## Staff Report for the Hearing Examiner

**Permit Number:** 16 05551

**Project Name:** CENTRAL KITSAP HIGH SCHOOL AND MIDDLE SCHOOL  
REPLACEMENTS

**Type of Application:** Conditional Use Permit

Figure 3 Topographic section from the football field toward the east and north property lines

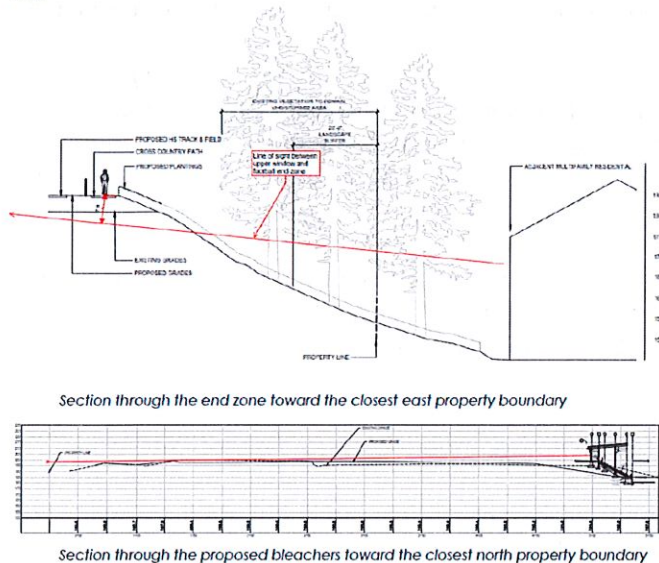
The field orientation, with the seating facing south, and the district's plan to cover the bleachers will, prevent noise emanating all directions to help mitigate impacts to abutting dwelling along the north property line at the same elevation. Staff agrees that the topography will break the line of sight for sound travel for the abutting multi-family housing, but the next row of units may be impacted. Staff generally supports the finding in the noise study, however staff has conditioned the project through SEPA to require that the applicant prepare a follow-up event noise study to verify that there is proper compliance.
